Variance Request Form

Variance: VAR-008
Request No.: Rev 0
Date Submit: 03/25/17
Date Agency Received: _____
Agency Reference No.: _____

Variance 008 (VAR-008) includes the addition of a batch plant facility in the 2-acre laydown yard (Yard 6) off McCain Valley Road to serve as the primary batch plant. The existing batch plant in the 80-acre parcel would remain to be used as back up if the primary batch plant is not able to supply enough concrete to meet the needs of the project and will supply concrete for the electrical pole foundations and underground 138kv south of I-8.

Figure 1
Northern Batch Plant Variance Overview
Tule Wind Project

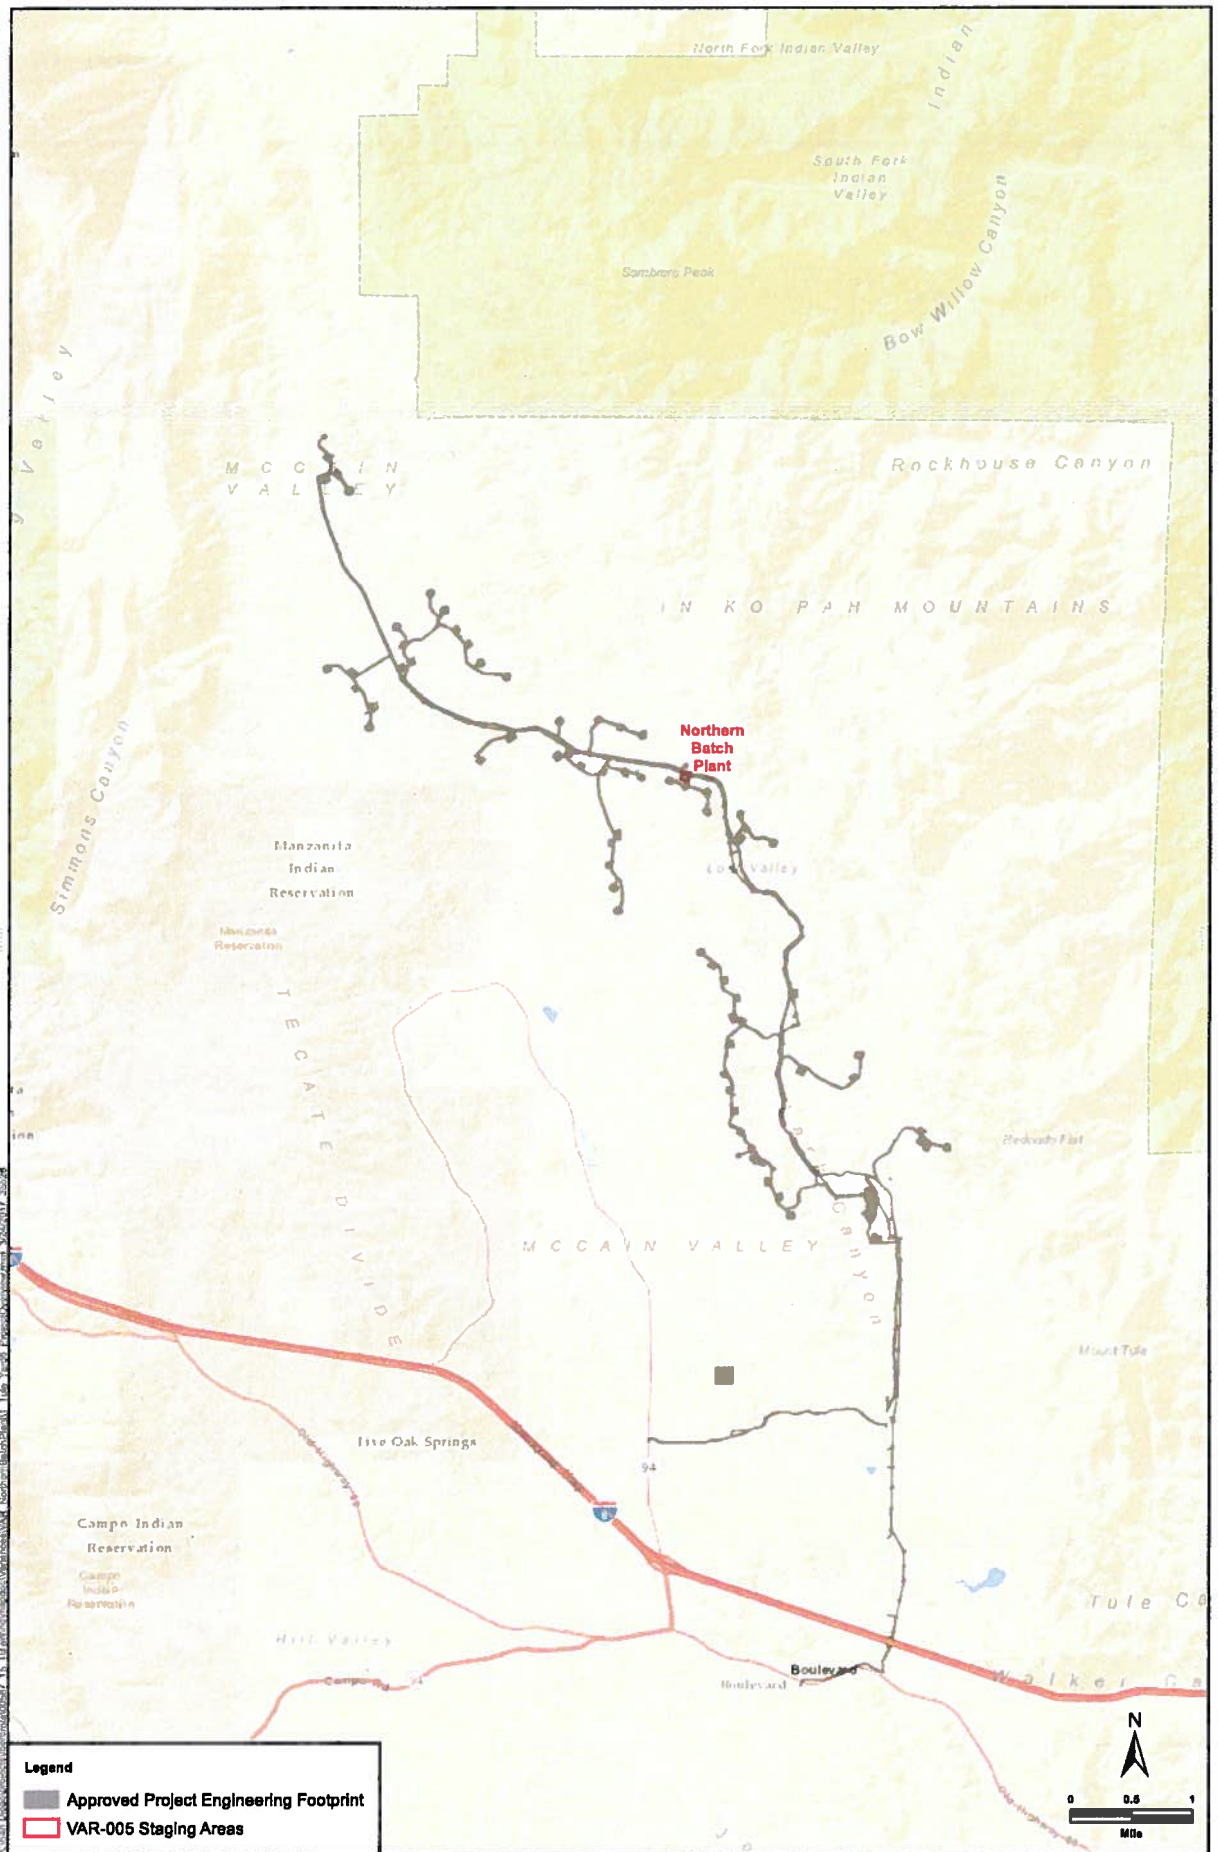
The North Batch Plant will be operated in Yard 6 consistent with Project permit and plan conditions, and will not include any additional impacts beyond the existing limits of disturbance. VAR-008 is located within previously surveyed areas, and no additional surveys were conducted for cultural or biological resources.

Tule Wind LLC shall meet the noise requirements specified in Section 3.0 of the Noise Mitigation Plan and County Ordinance Section 3436.404. The optional sound attenuated enclosure shall be installed at each of the two generators to meet the requirements of Section 3.0 of the Noise Mitigation Plan and County Ordinance Section 3436.404, unless Tule Wind LLC is able to demonstrate that the requirements of Section 3.0 of the Noise Mitigation Plan and County Ordinance Section 3436.404 are being met through other means.
